179th Street Circulation and Access Management Plan

Roadway Amendments-179th Access Plan (CPZ2021-00013)

Re: CPZ2021-00013 – 179th Street Management & Circulation Plan

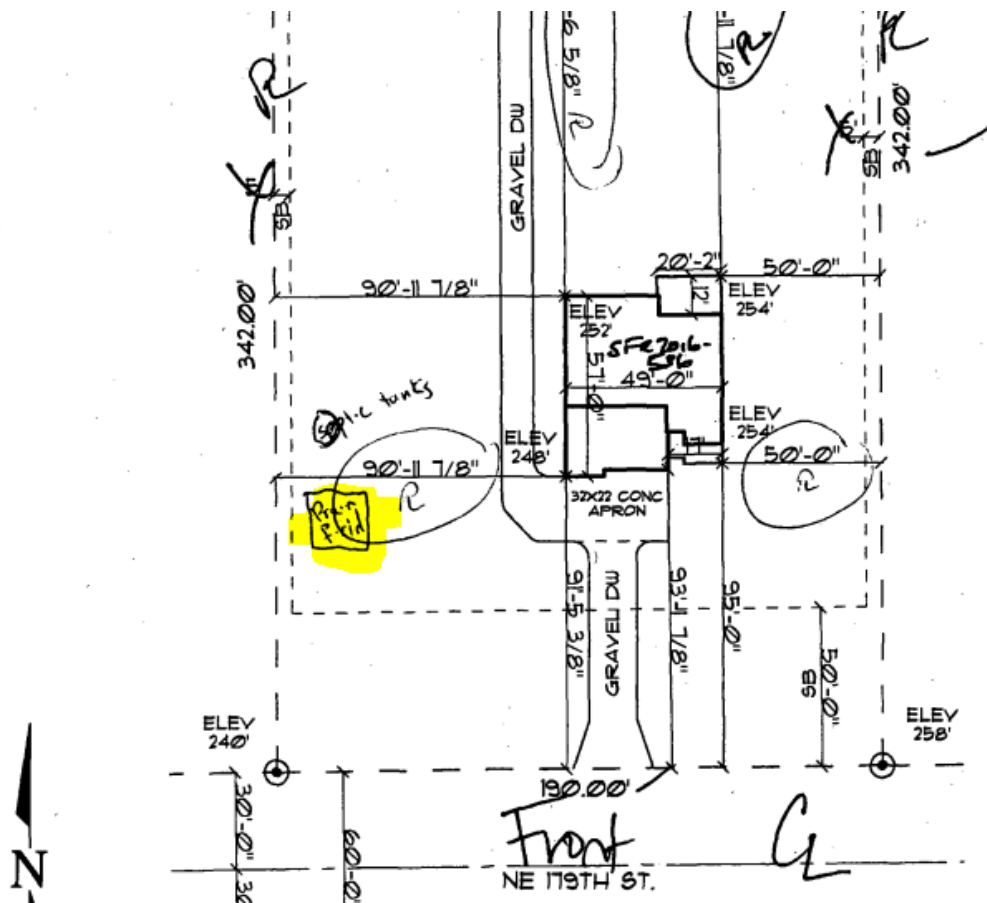
We are trying to figure out exactly how this impact our property. Meaning specifically how much of our property will be used for the expansion of 179th street.

The roundabout construction at NE 29th Avenue and NE 179th Street schematic is shown below. I did a sloppy job of showing where your property is located in relation to this project.

179th Street when widened to its principal arterial classification required 100 foot right of way, 72 feet of paved surface. Currently 179th Street is approximately 60 of right-of-way in front of your property. Therefore, and additional 20 feet of right of way will be needed on both sides of the street. The drain field shown on your plans when your home was permitted in 2016 show that your drain field is at least 50 feet from the road. The road expansion, when it occurs, should not impact your drain field. This expansion is not going to happen in at least 6 years from now.

Subject: CPZ2021-00013 179th St. Access Management & Circulation Plan SEPA Comments

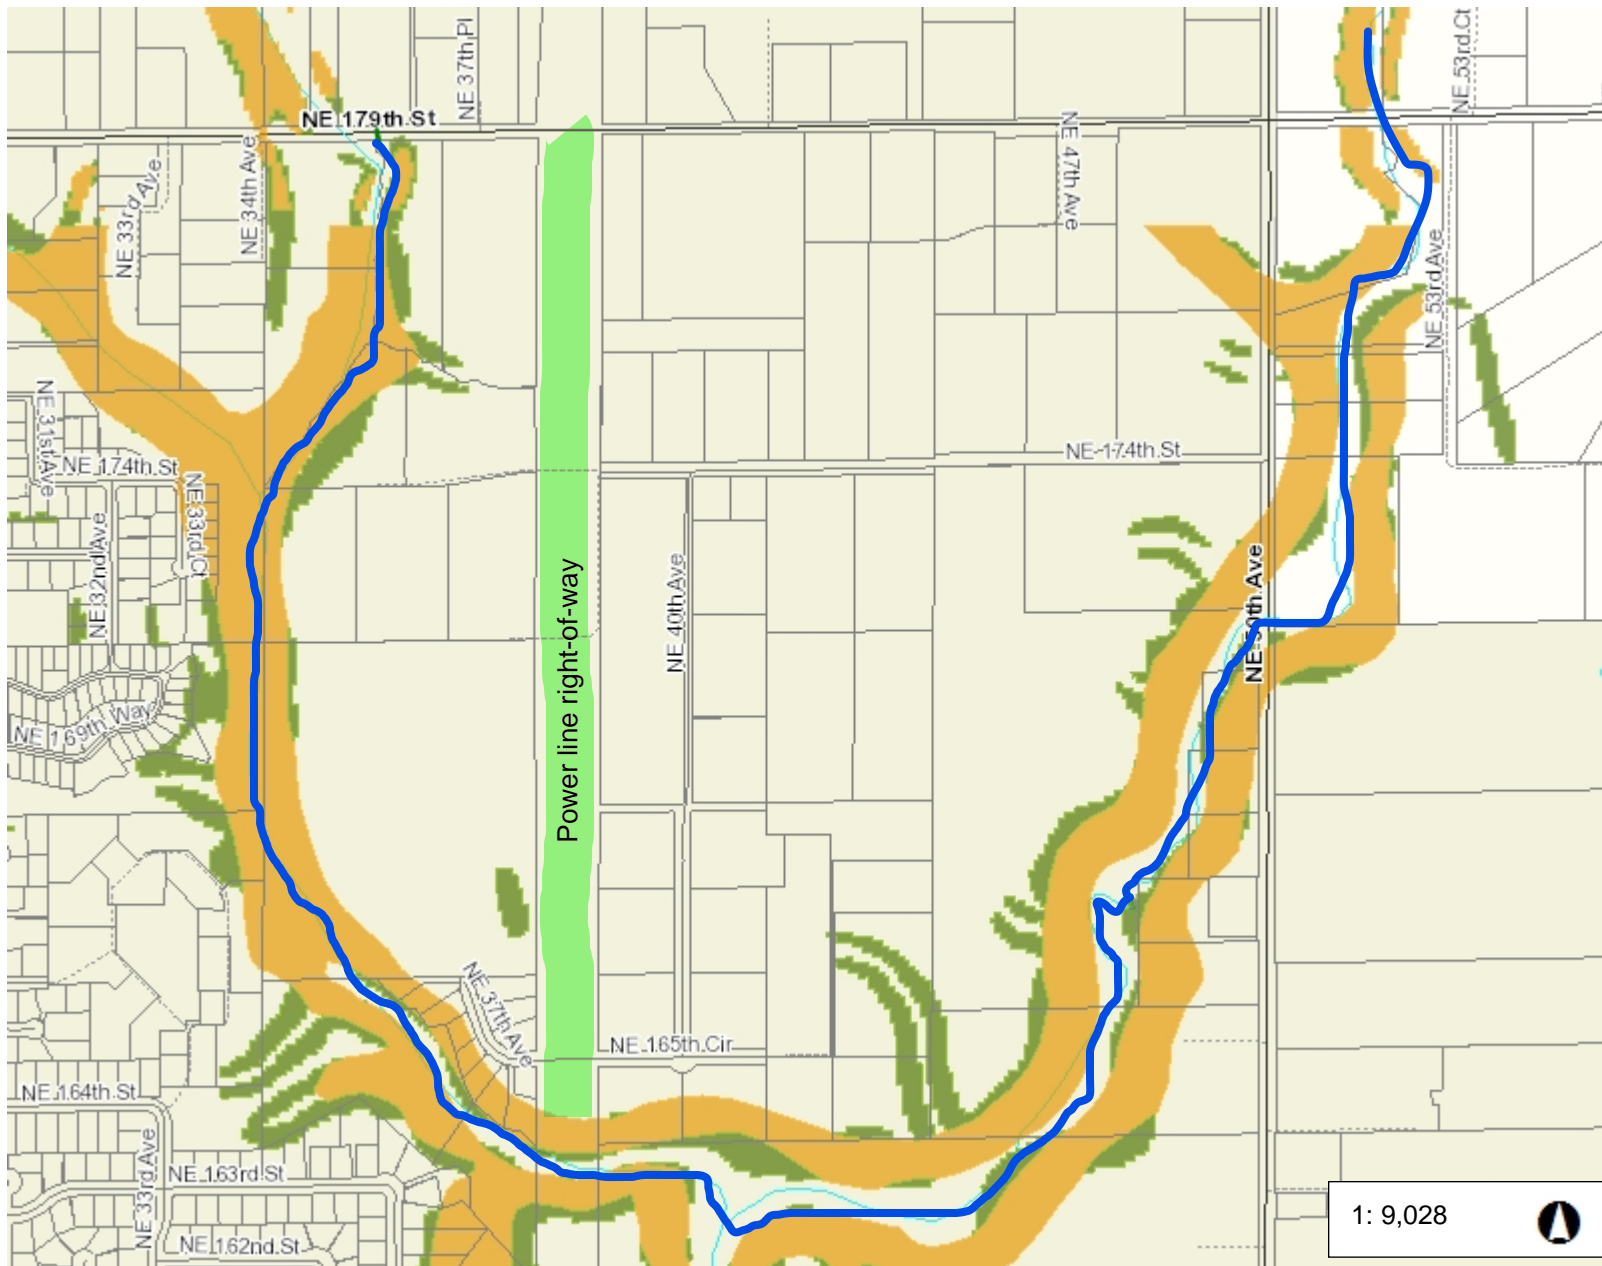
I do not understand the street shown as a Collector at 45th Ave between 174th and 179th. The map legend shows it as a proposed Arterial but it is not shown with yellow highlighting as an addition? Back in 2009 when the Mill Creek Subarea plan was adopted the proposed 39th Ave replaced what had been a proposed street at this location. (See County Staff Report of Feb.19, 2009 Action Item 2 by Mike Mabrey) So is this an inadvertent mapping error of this former street or is it a new proposed Collector street that has not been highlighted as an addition? This is of great importance to me as it is shown along my east property line and has potential significant impact to my, and my neighbors, properties.

A Collector street has access restrictions, UDC 40.350.030 B.4.c.(2)(a) reads: " *Urban Collectors. No residential driveways in the urban area will be permitted unless no other access to the site exists or can be made available*". My and my neighbor's R1-7.5 zoned properties have access to 174thSt., thus this proposed 45th Ave Collector could not be used to provide direct driveway access to new lots based on these restrictions. And if subdivided a 30 ft. strip of land along my 840 ft. eastern boundary would be taken for right-of-way which is over 25,000 sq.ft. enough area for more than three 7,500 sq.ft. lots. Plus a developer would be obligated to build a half street at a cost of many thousands of dollars for a street that does not directly serve any new lots.

I strongly request that 45th Ave. along the east side of my property be deleted, and the east-west 176th St. be deleted as well since it is not an Arterial or Collector. Adding these planned streets to the Arterial Atlas will reduce the value of my property and may constitute a taking in violation of the 5th Amendment.

Thank you for your letter and request for amending the proposed 179th Street Access Management and Circulation Plan. Upon further review of our proposal, I agree that the proposed Collector running North/South at approximately 45th Avenue should be revised. I will be amending the proposal to classify this as a neighborhood circulator, rather than a collector. This neighborhood circulator classification allows direct driveway access, as you note in your letter. We have heard from your neighbors on potential safety concerns at the NE 174th Street/50th Avenue intersection.
